**DRAINAGE LETTER
FOR
STERLING RANCH ROAD
CROSSING OF SAND CREEK**

Engineering Review

PCD-ENGINEERING REVIEW COMMENTS
IN BLUE BOXES WITH BLUE TEXT

CCES responses in RED

Water Surface Profile Plot for Culvert: Sterling Ranch Road Crossing

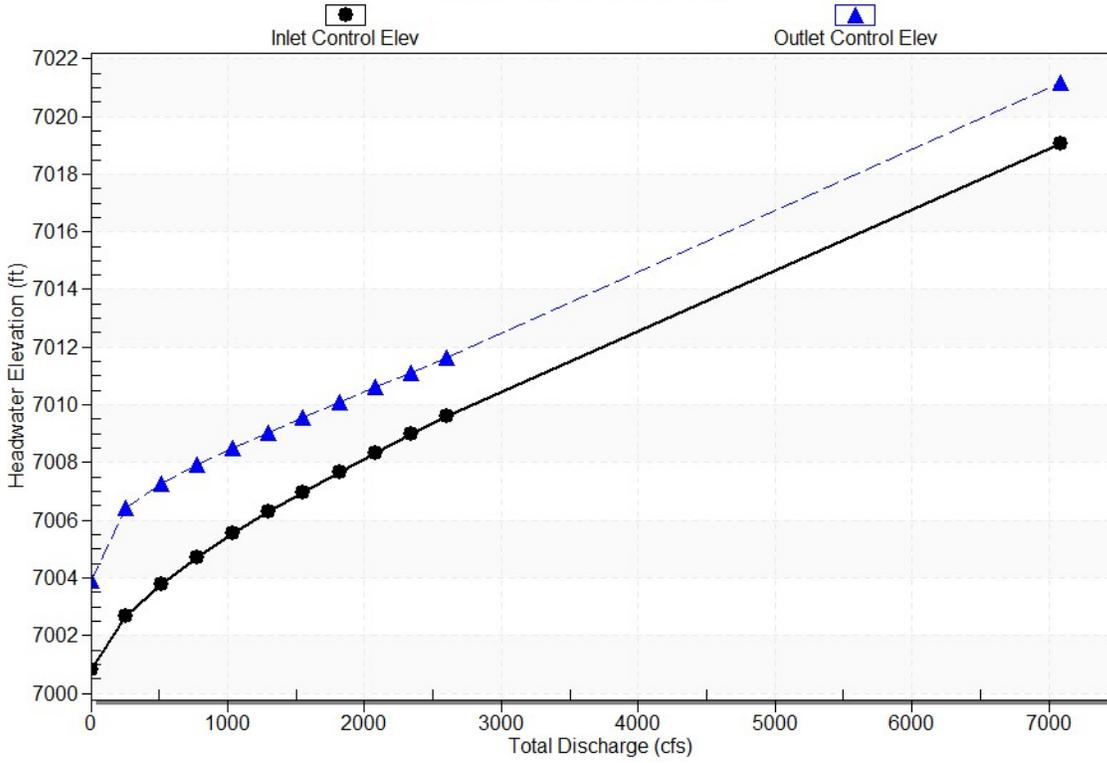
These two facilities aren't constructed yet -
what is the freeboard with the FEMA flows
and the 1911.5 cfs? Added this info. and calculations
to narrative and Appendix.

7013.09 - 7011.6 = 1.49'
freeboard for 2,600 cfs

2' freeboard for 2,340 cfs

BRIDGECOR STEEL BOX STERLING RANCH ROAD- CO SPRINGS COLORADO SPRINGS, CO

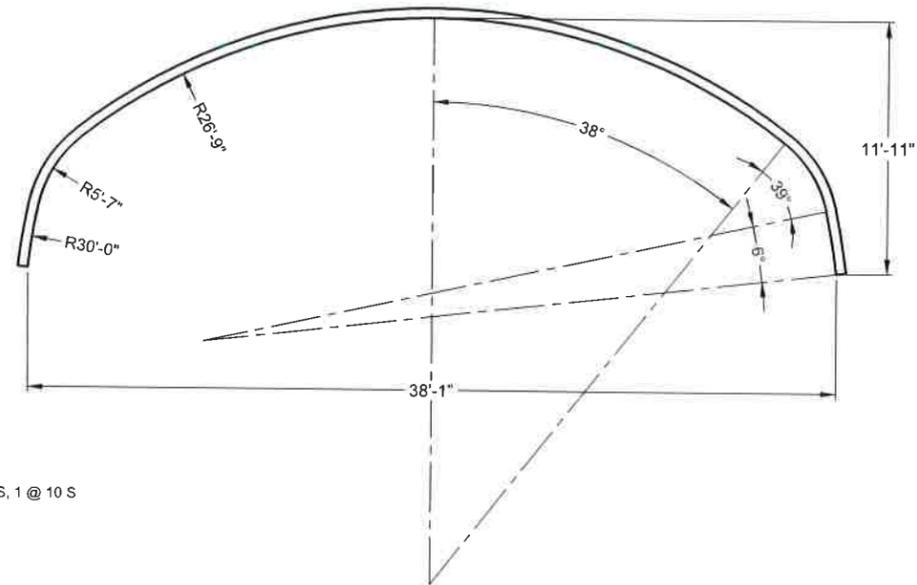
provide revised version
